# Product Change Notification

**Change Notification #:** 115443 - 00  
**Change Title:** Intel® Edison Breakout Board Kit,  
Intel® Edison Compute Module,  
Intel® Edison Kit for Arduino\*,  
PCN 115443-00, Product Marking,  
Marking Change  
**Date of Publication:** April 14, 2017

## Before VS After

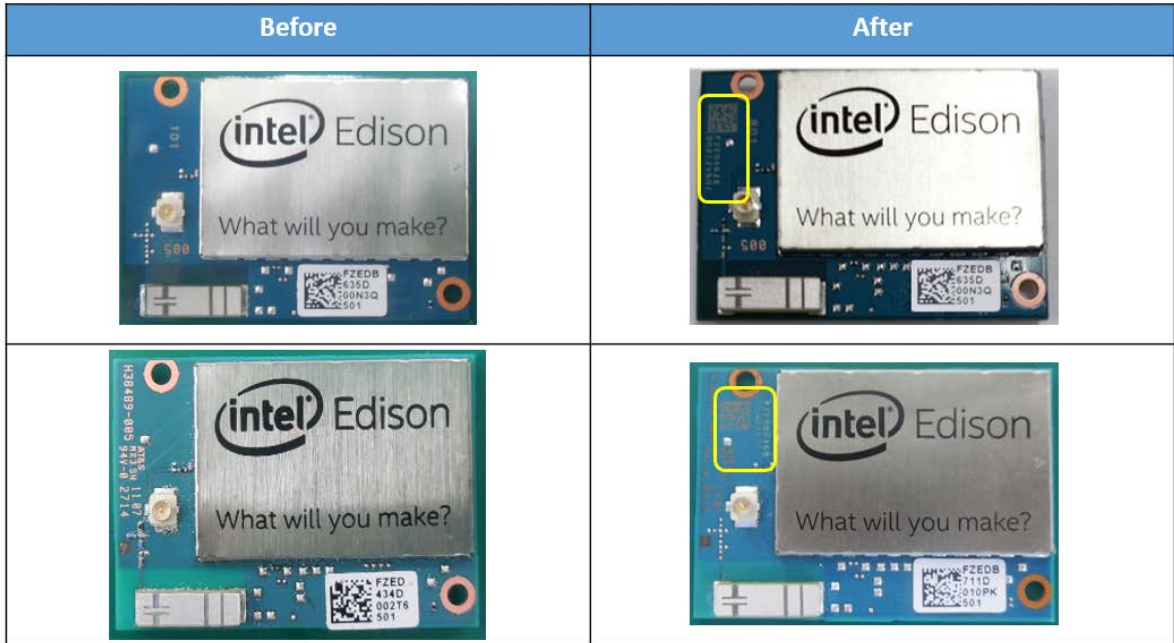
The manufacturing site will add a laser mark to PCBA on Edison to enable better process control and traceability.

Anticipate no impact to customers on form/fit/function. However the addition of the laser mark on the PCBA will be visible to customers. The intention of the PCN is to provide for informational purposes only. See below BEFORE & AFTER picture for reference.
